UNITED STATES
DEPARTMENT OF THE INTERIOR
BUREAU OF LAND MANAGEMENTOperator Copy
EMNRD-OCD ARTESIA
REC'D: 8/05/2020FORM APPROVED
OMB NO. 1004-0137
Expires: January 31, 2018**SUNDRY NOTICES AND REPORTS ON WELLS**
Do not use this form for proposals to drill or to re-enter an abandoned well. Use form 3160-3 (APD) for such proposals.**SUBMIT IN TRIPLICATE - Other instructions on page 2**

EOG Resources, Inc. plans to plug and abandon this well as follows:

Jackson B #17

Permanent Abandonment of Federal Wells
Conditions of Approval (LPC Habitat)

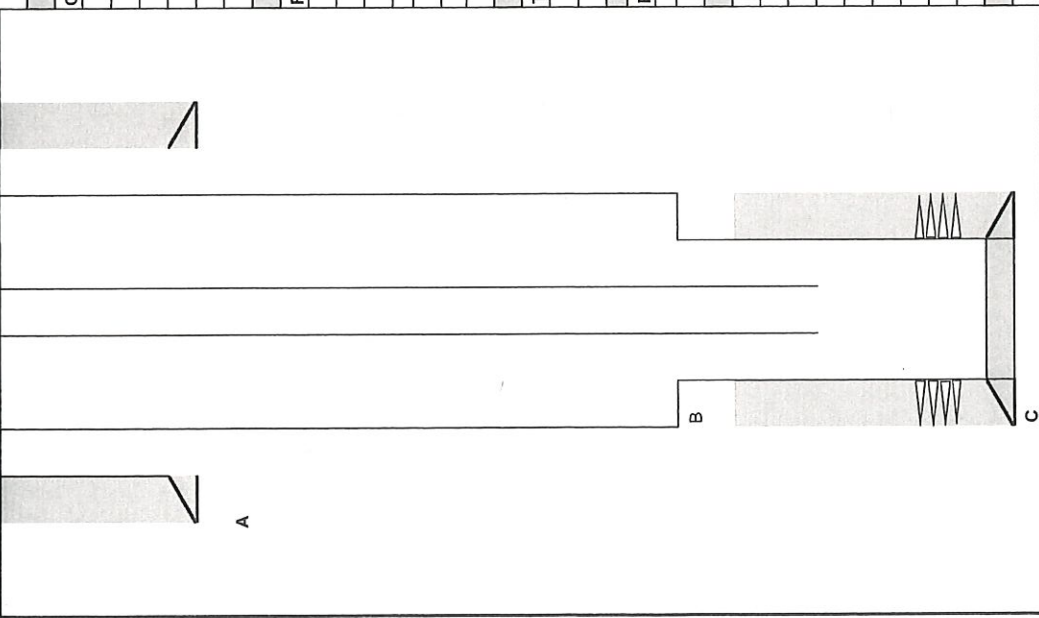
**** BLM REVISED ** BLM REVISED ** BLM REVISED ** BLM REVISED ** BLM REVISED ****

- 1 Set CIBP at 2829 ft with 35 ft of CLS C on top.
- 2 Perforate at 581 ft. Attempt to establish Circulation or spot I/O. Requires 25 SX (142 ft) CLS C cement plug 439 ft - 581 ft. WOC
- 3 Spot a 10 SX (57 ft) CLS C cement plug 0 ft - 57 ft. WOC & Tag Plug. This will plug the Top.
